**August 10, 2021
7:00 PM
Planning Board Agenda**

City of Beacon Planning Board Agenda
08/10/2021

Public hearing on application for Special Use Permit and Site Plan Approval, accessory apartment, 1 Wilson Street, submitted by Jon Moss

AC-01	SITE PLAN, DIAGRAMS
AC-02	SURVEY
AC-03	ACCESORY BUILDING PLANS

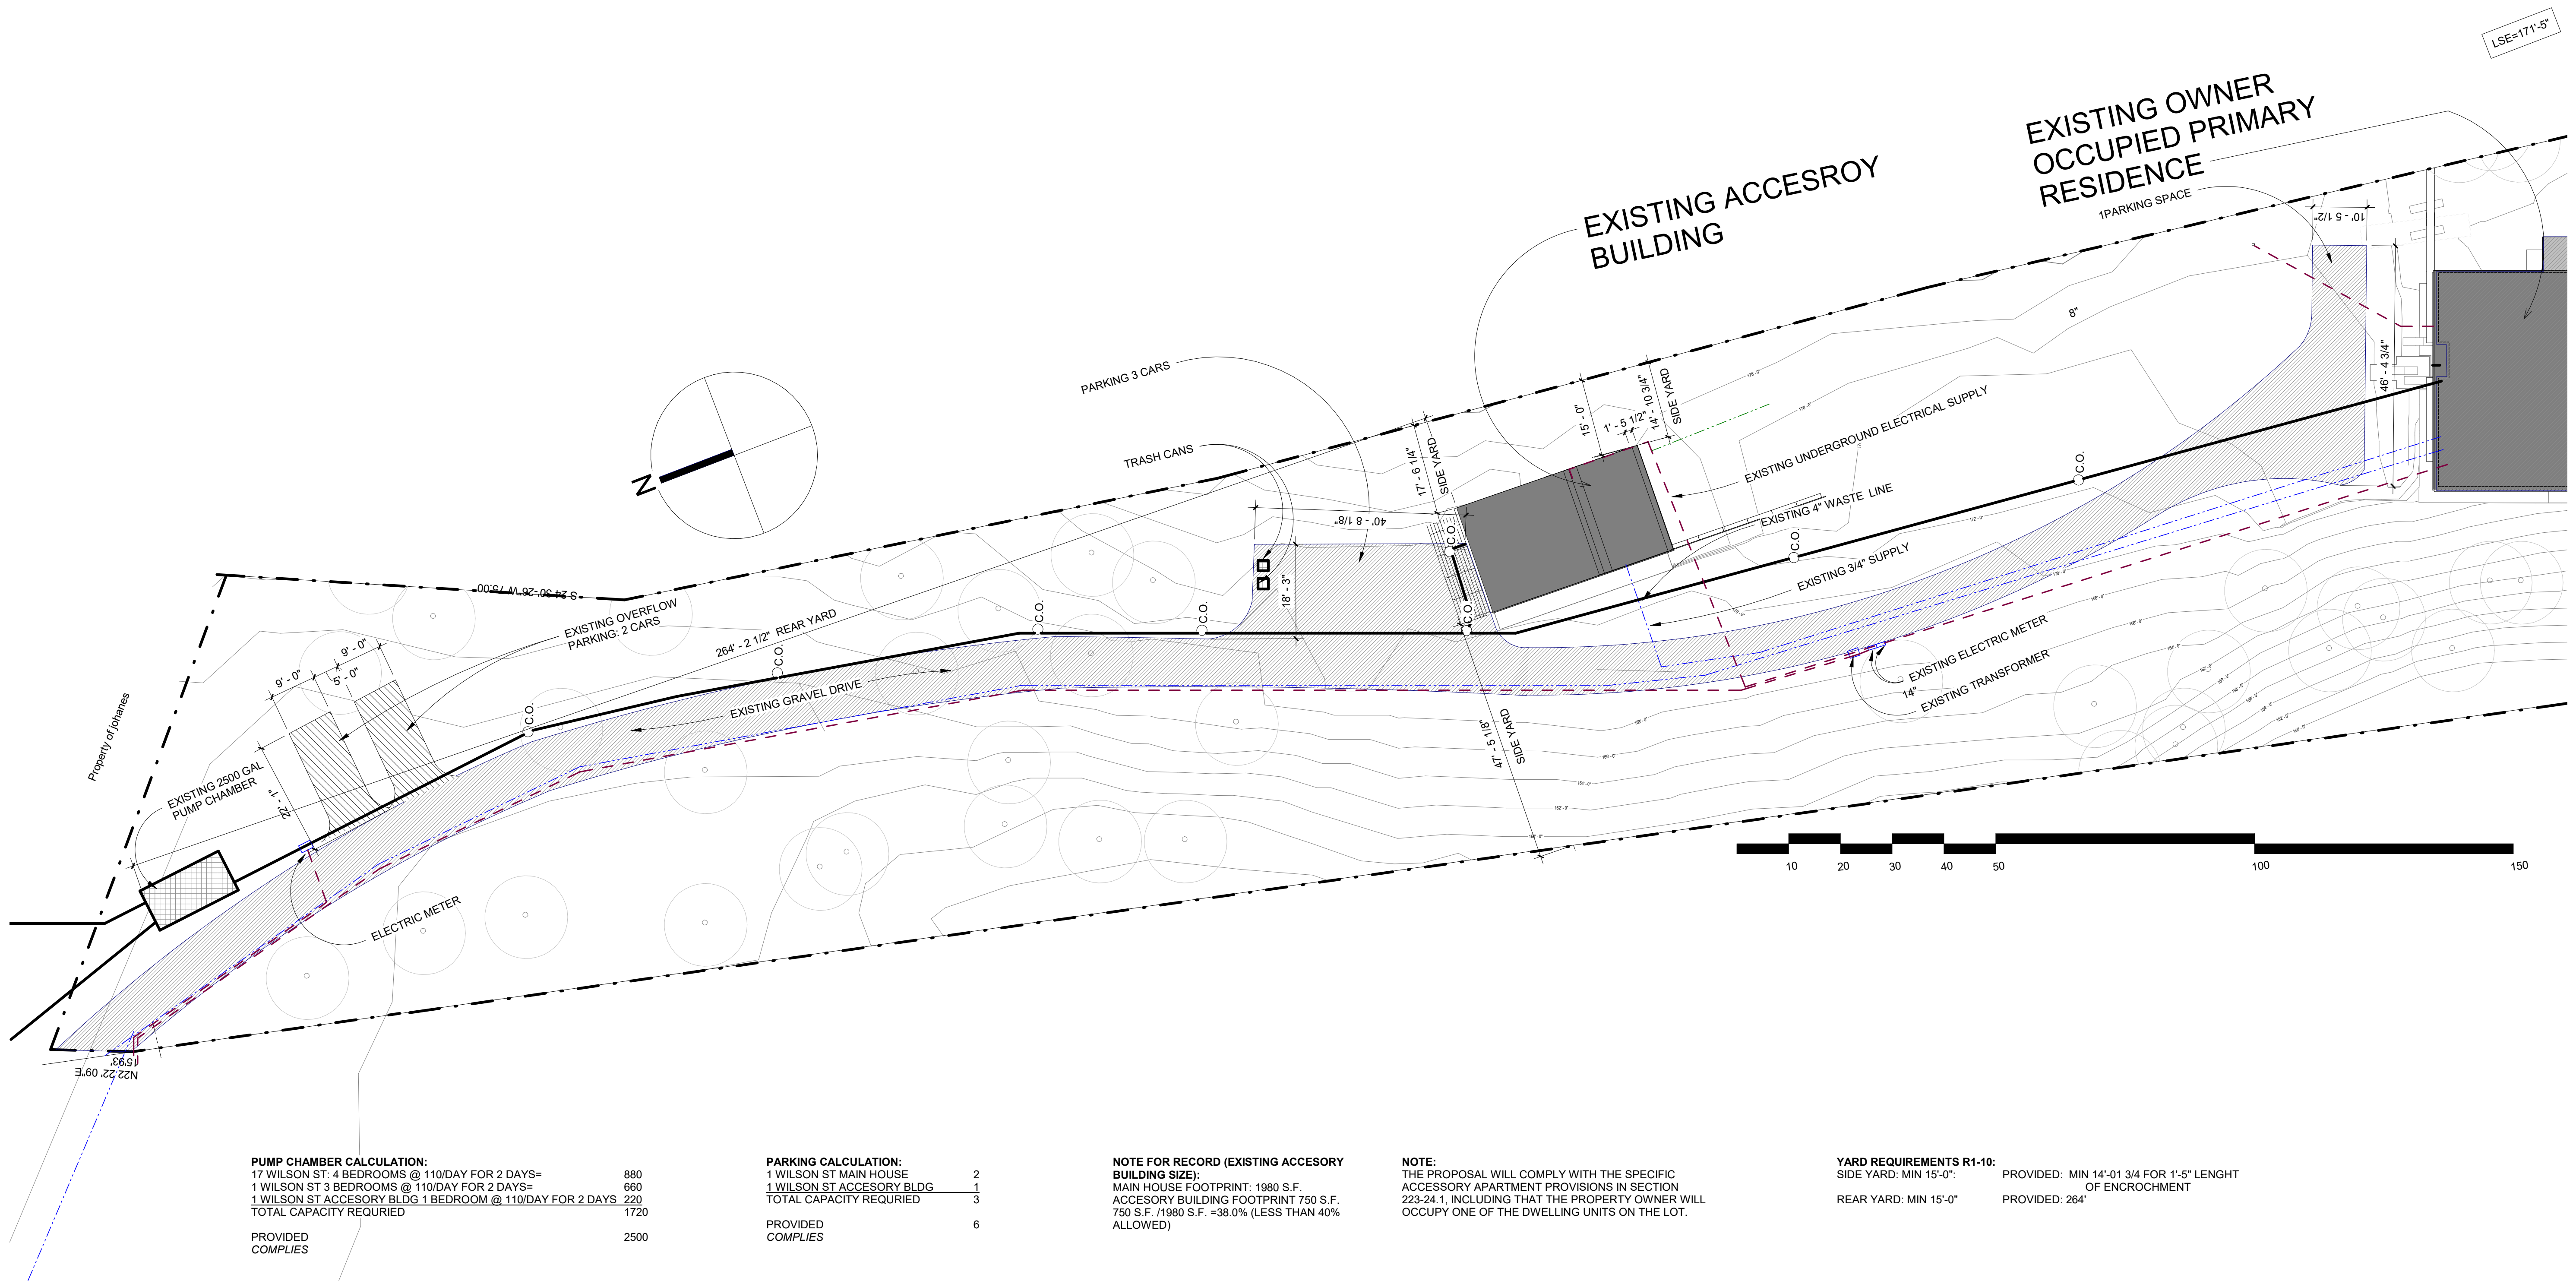
1. Sheet AC-01 should include a note confirming that the proposal will comply with the specific accessory apartment provisions in Section 223-24.1, including that the property owner will occupy one of the dwelling units on the lot.
2. All my other comments have been addressed.

ACCESS & UTILITY EASEMENTS

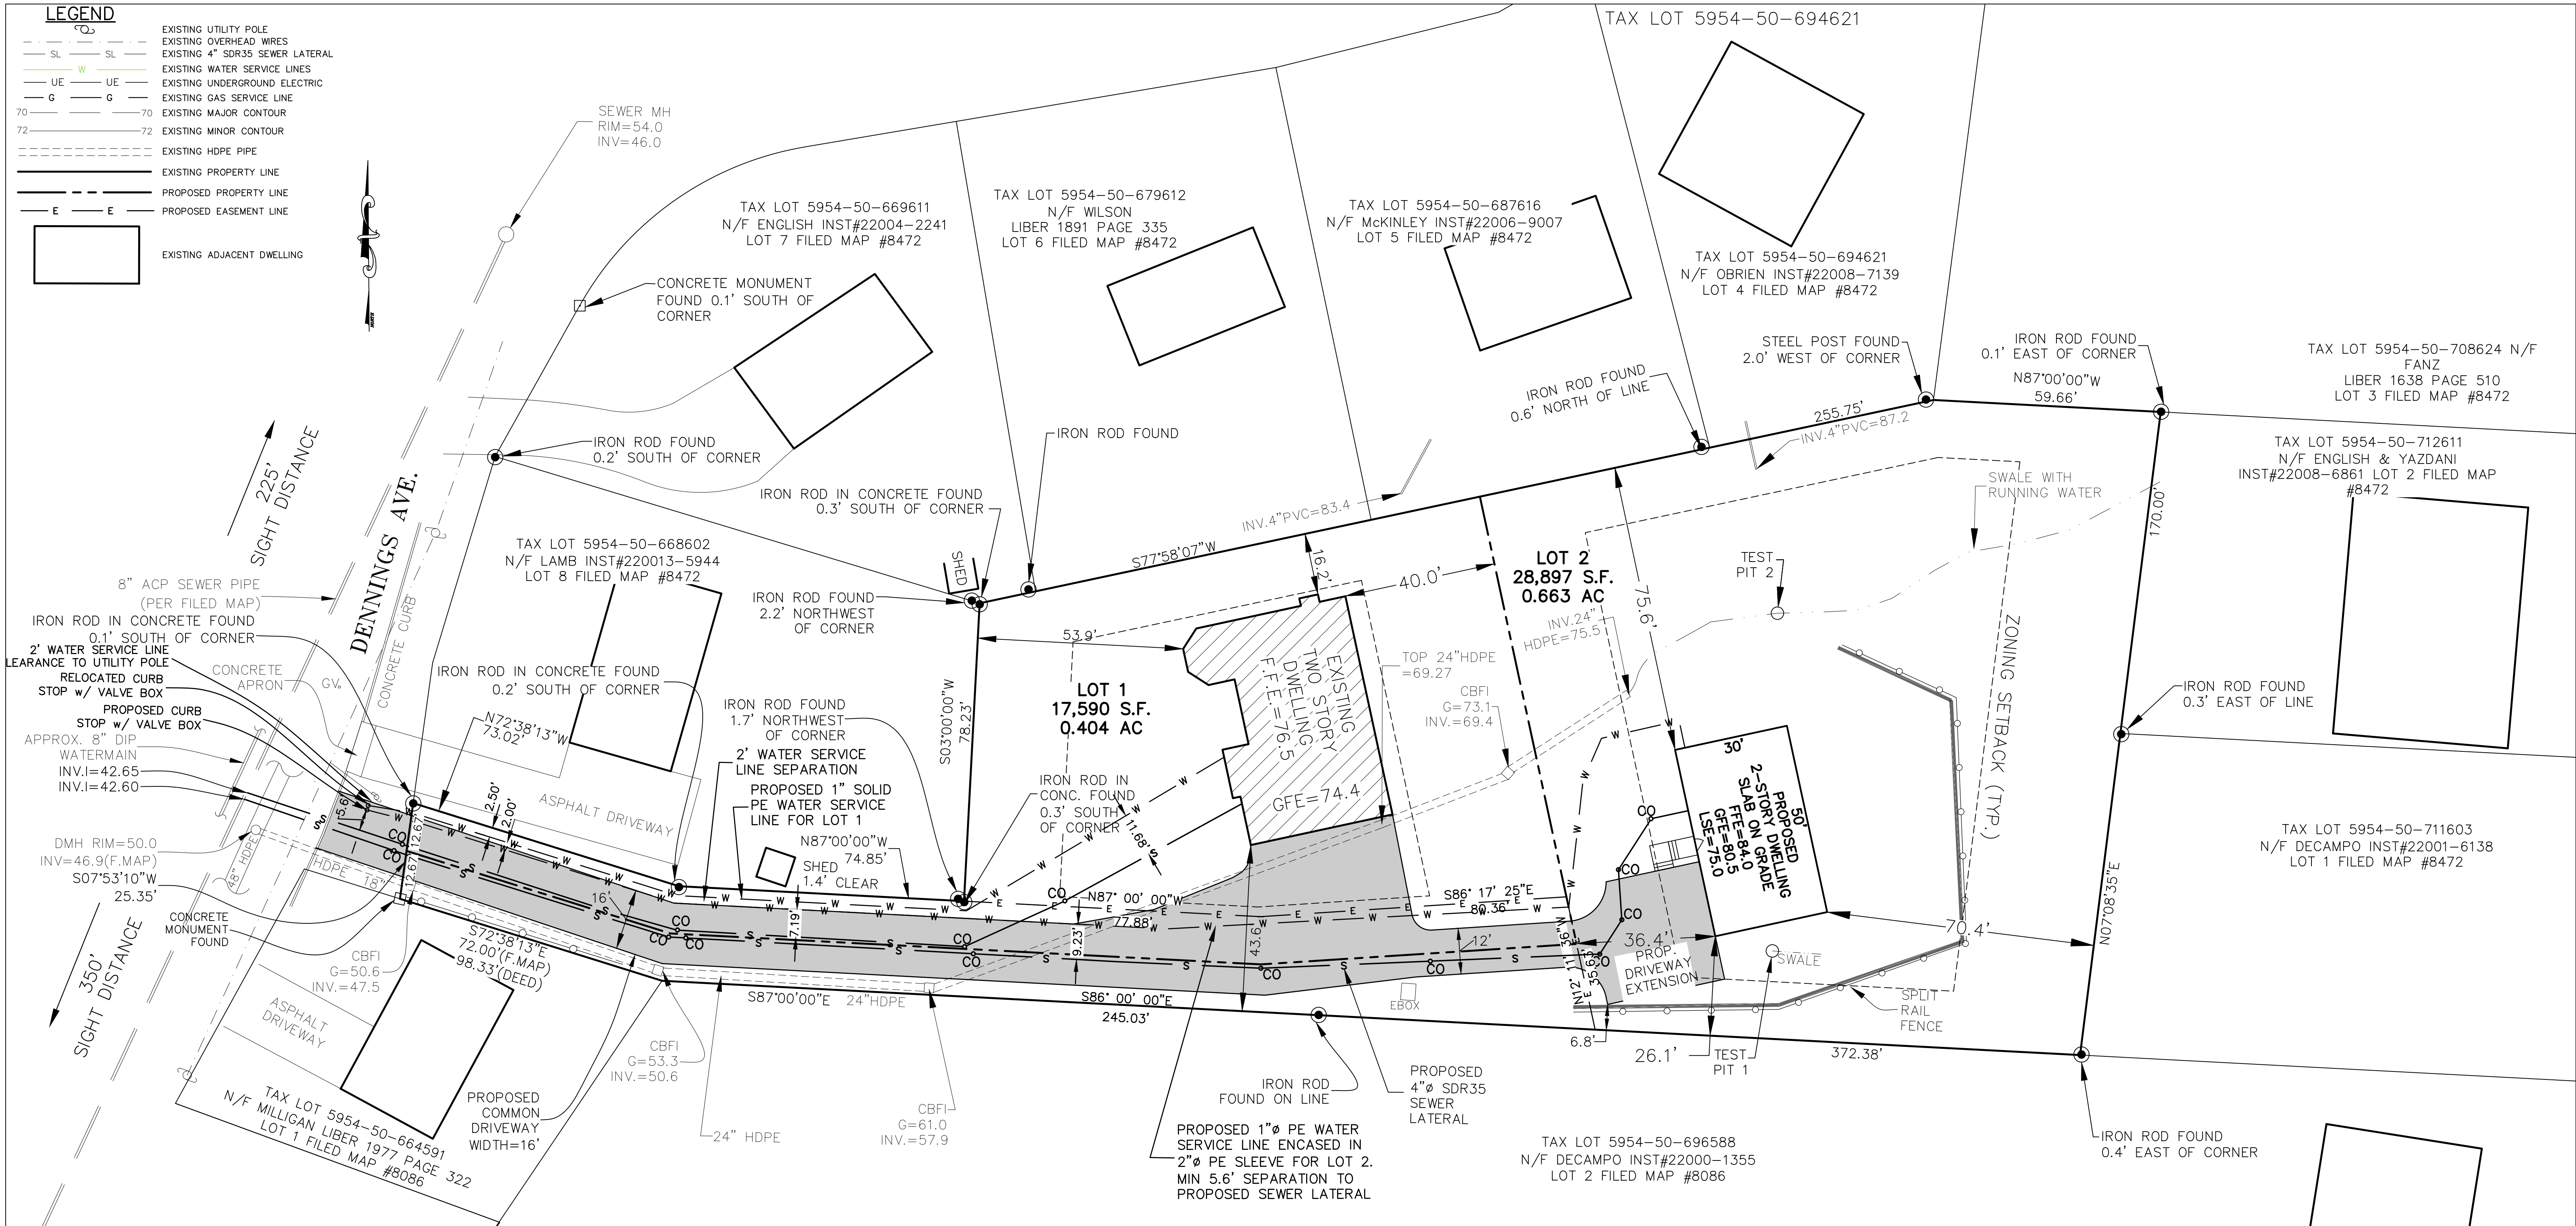
5. Sheet 3 of 6, Access & Utility Easements: The existing cleanout (CO) located to the east of the residence on Lot I should be removed from the plan, as the line is proposed to be removed.

Response: The existing cleanout has been removed from Sheet 3.
